# Access Compliance Report

## Public Rights-of-Way (Curb Ramps)

Intersection ID: 10017280	Main Street: SUNSET_RD	Cross Street: N/A	Location: S
ADA ID: DC1C340C84D9	Ramp Type: Directional1	Initial Pass/Fail: Fail	Overall Compliance: No
		Severity Score: 12.5

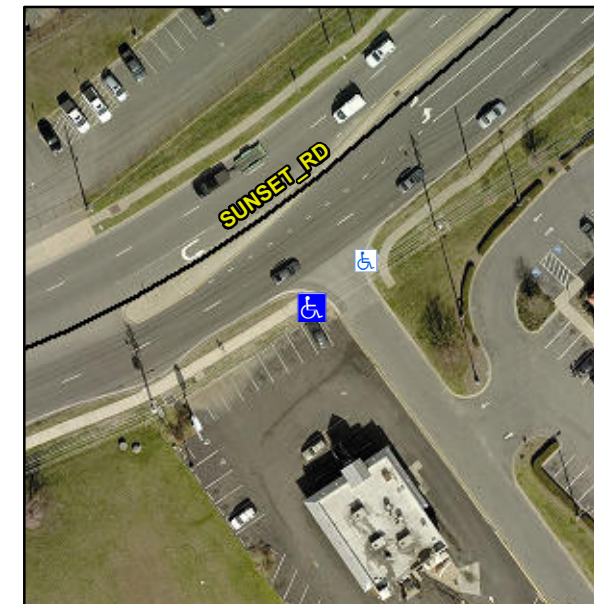
**R304.2.2**

Compliance	Description	Data	Compliance	Description	Data
N/A	Ramp Length (in)	132.0	N/A	Grade Break?	N/A
Yes	Ramp Width (in)	69.0	N/A	Grade Break Slope (%)	0.0
No	Ramp Slope (%)	8.8	N/A	Grade Break XSlope (%)	0.0
Yes	Ramp XSlope (%)	0.1			
N/A	Flare Type LT	N/A	N/A	Flare Type RT	N/A
N/A	Flare Slope LT (%)	N/A	N/A	Flare Slope RT (%)	0.0
N/A	Flare Traversable LT?	N/A	N/A	Flare Traversable RT?	N/A
N/A	Landing Length (in)	0.0	N/A	DWS Provided?	N/A
N/A	Landing Width (in)	0.0	N/A	DWS Contrast?	N/A
N/A	Landing Slope (%)	0.0	N/A	DWS Length (in)	N/A
N/A	Landing X Slope (%)	0.0	N/A	DWS Full Width?	N/A
N/A	Landing Curb? (Y/N)	N/A	N/A	DWS Offset LT (in)	N/A
N/A	Shared Landing?	N/A	N/A	DWS Offset RT (in)	N/A
N/A	Gutter Ponding?	0.0	N/A	Gutter Slope (%)	N/A
N/A	Gutter Lip Ht (in)	0.0	N/A	Gutter X Slope (%)	N/A
N/A	Painted X Walk1?	No		Road Slope (%)	0.9
	X Walk 1 Direction	To NE		Road X Slope (%)	3.8
	X Walk 1 Width (in)	N/A		Clear Space?	N/A

**Remove & Replace Entire Ramp.**
